STAFF REPORT
(One-Step Final Plat)

CASE NUMBER: S/D 99-46 - GILNOCKIE LOCHS ADDITION

LOCATION: South side of 77th St. North, East of Greenwich Road

VICINITY MAP

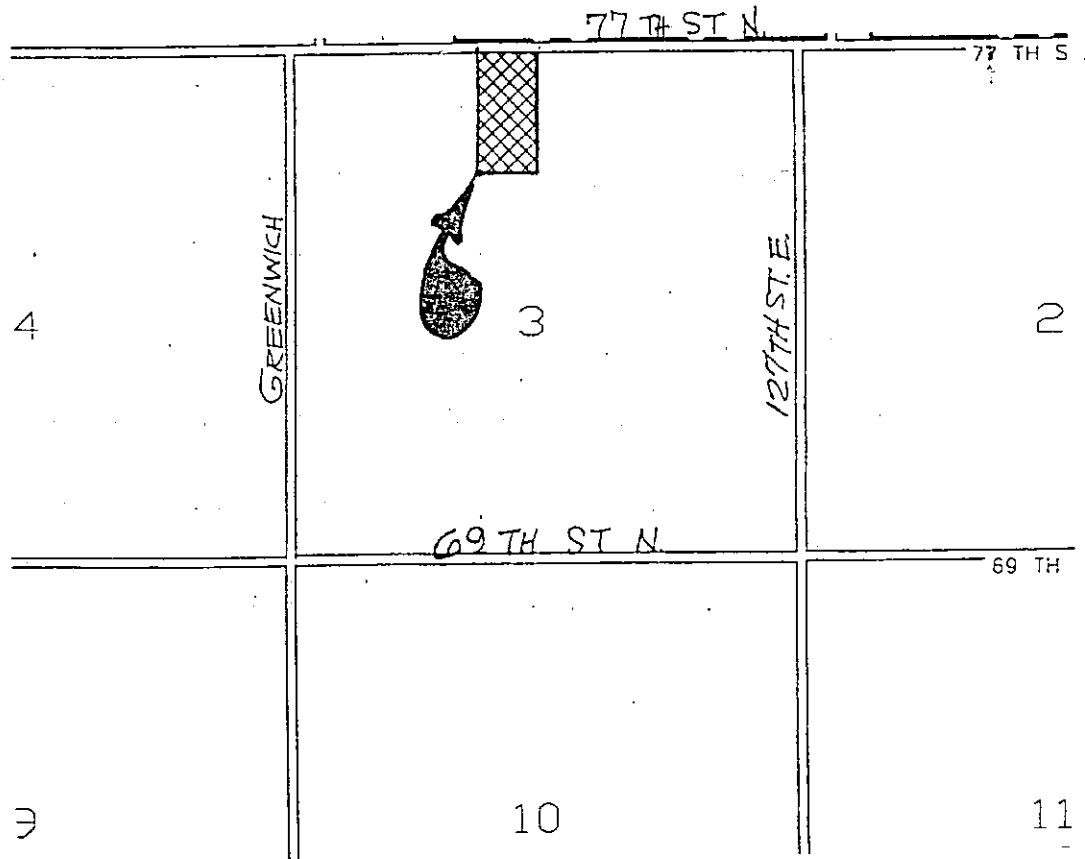
- D. **County Engineering** needs to comment on the status of the applicant's drainage plan.
- E. **County Engineering** needs to comment on the access controls. The plat proposes one access opening per lot along 77th St. North.

- I. The northeast tie point needs to reference Section 3.
- J. The minimum building pad elevation referenced in the plat's text needs to be specified in NGVD.

- K. Both lots exceed the maximum lot width to lot depth ratio of 2.5 to 1. A modification will need to be approved.
- L. The MAPC Chair should be revised to reference "William M. Johnson".
